Addendum No. 2
CHALK BLUFF IMPROVEMENTS PROJECT PART A –
OPERATIONS BUILDING AND PROJECT PART B – UPS
UPGRADES

PWP Bid No.: WA-2017-008
TMWA Capital Project No.: 11-0001
October 18, 2016

Plumbing Schedules

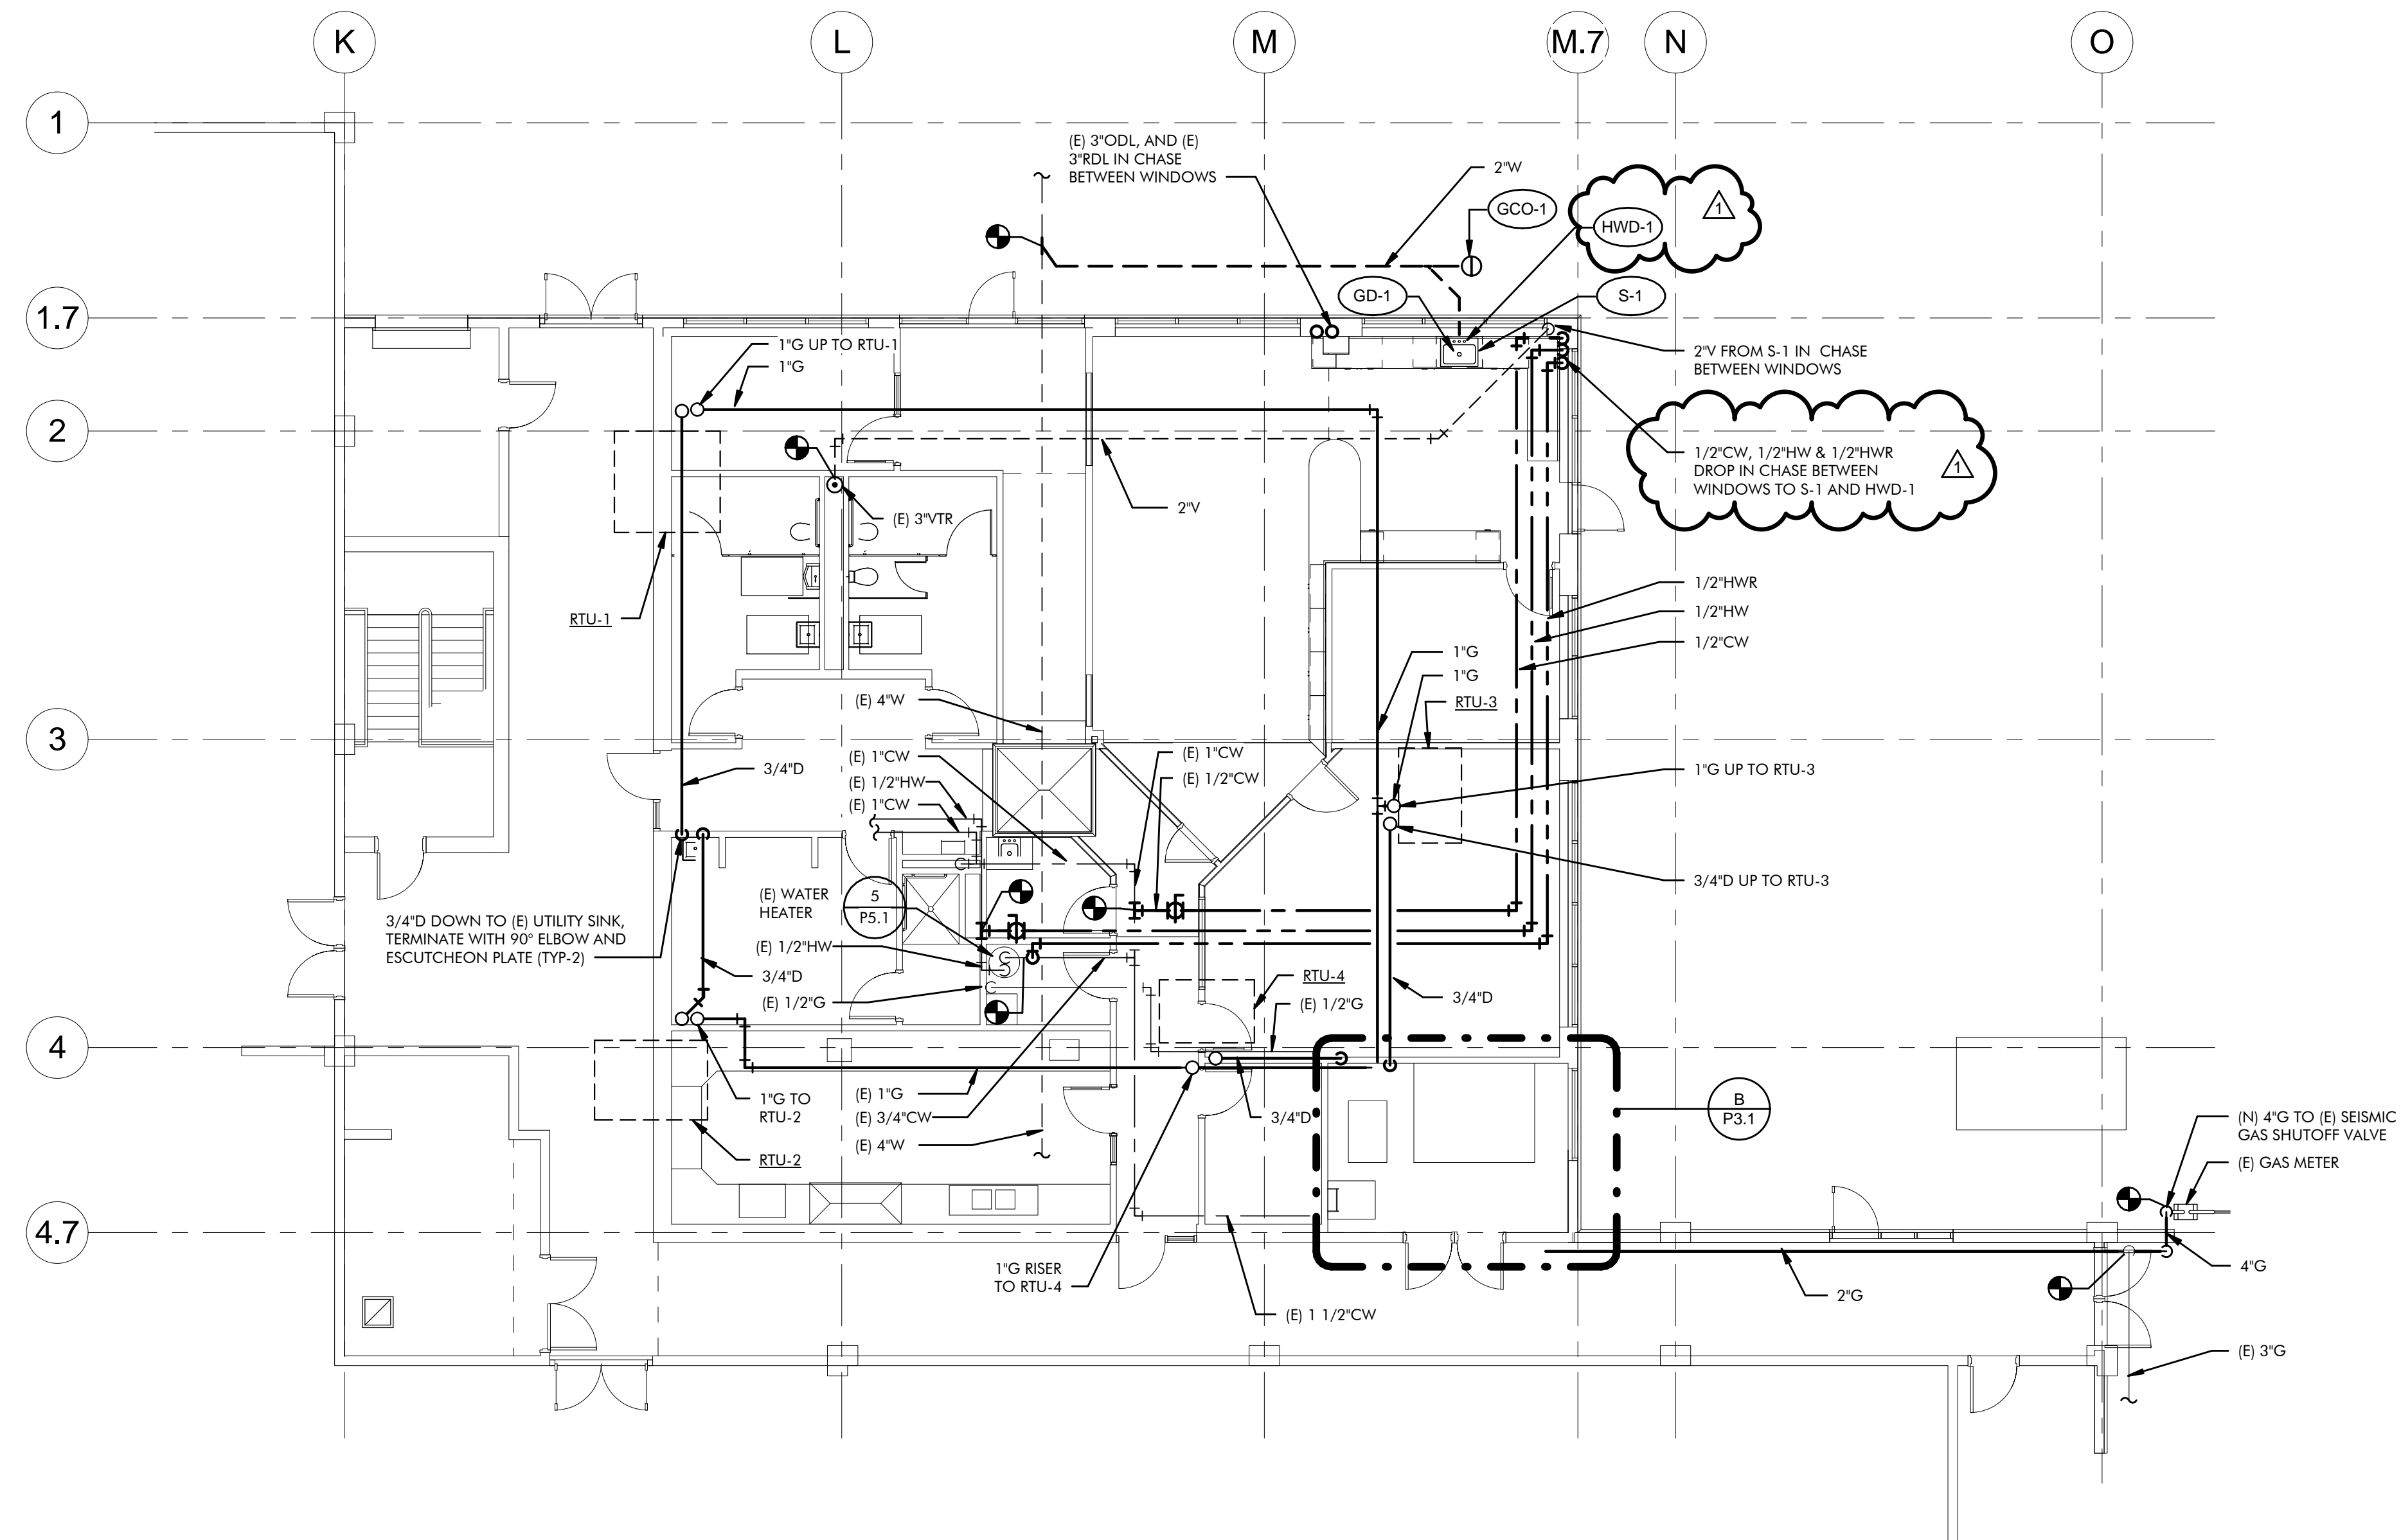
Addendum Item 2.1: Reference attached revised sheets P0.1 Plumbing Schedule and P2.1 Plumbing Floor Plan, revision date 11/6/2015, for added Hot Water Dispenser and associated plumbing requirements.
